INITIAL FIRE SAFETY INSPECTION REPORT

Habitus Fashion Ltd. (Extension 2)

RSC ID: 26547

Date: 24-December-2025

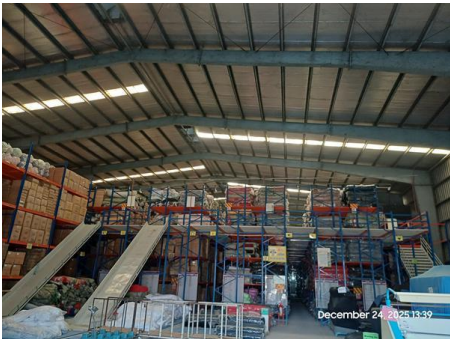
F-08	Means of Egress	Based on the number and location of emergency lights observed, adequate illumination levels were not anticipated along egress routes. Location: All buildings and sheds.	Test the emergency lighting system on each floor and provide additional emergency fixtures to provide adequate illumination along the means of egress. Provide a minimum illumination of 10 lux at the floor level within exit stairs and exit discharge paths and minimum 2.5 lux along exit access aisles. Illumination on means of egress shall meet in accordance with RSC Technical Guidelines (Standard)¹ V1.0 Section 10.12.2.	Within 3 Months

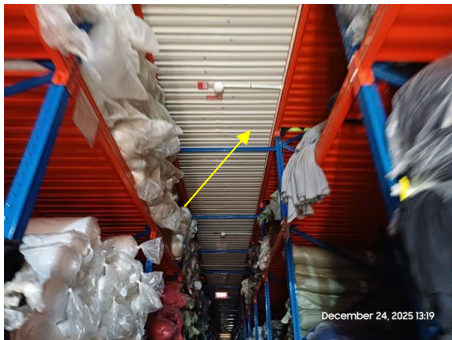
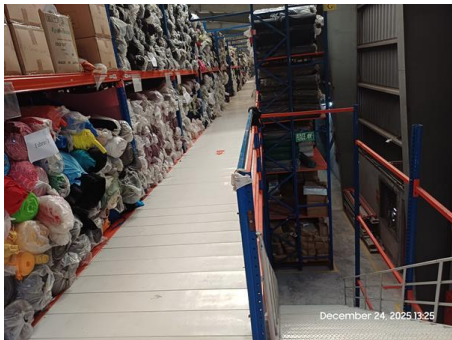
F-10	Means of Egress	The egress path (landing) along means of egress has obstructed by door leaf. Location: South-Easr Exit.	Modify the door swing/exit arrangement as required. Keep egress paths clear of obstruction in accordance with section 6.3.9 of RSC Technical Guidelines (Standard)¹ V1.0. Means of egress shall be maintained continuously free and clear of all obstructions or impediments to full instant use in the case of fire or other emergency. No furnishings, decorations, or other objects shall obstruct exits and access to exits. Nothing shall obstruct or impede visibility to exits.	Within 1 Month
